TITLE: ardio_st32f205r

Sheet: 2/3

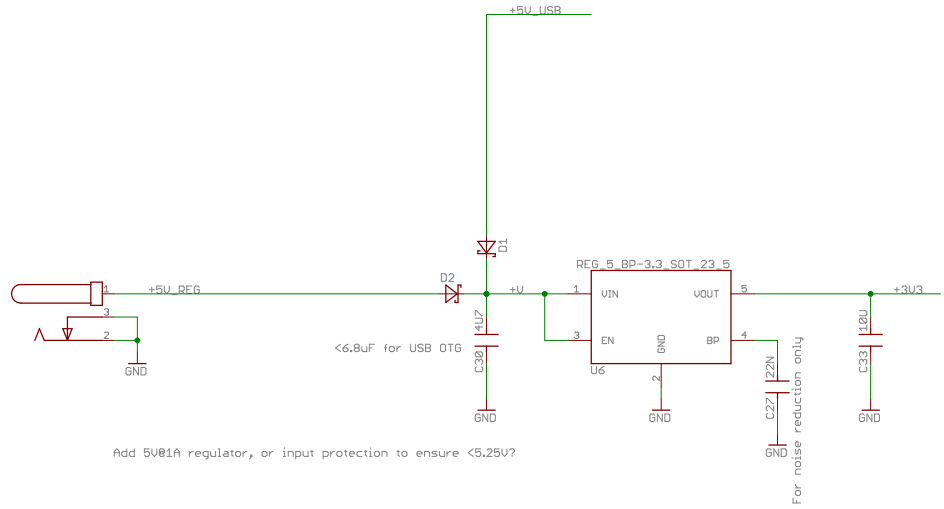
Change to less expensive socket?
Verify switch pin-out

Add 5V@1A regulator, or input protection to ensure <5.25V?
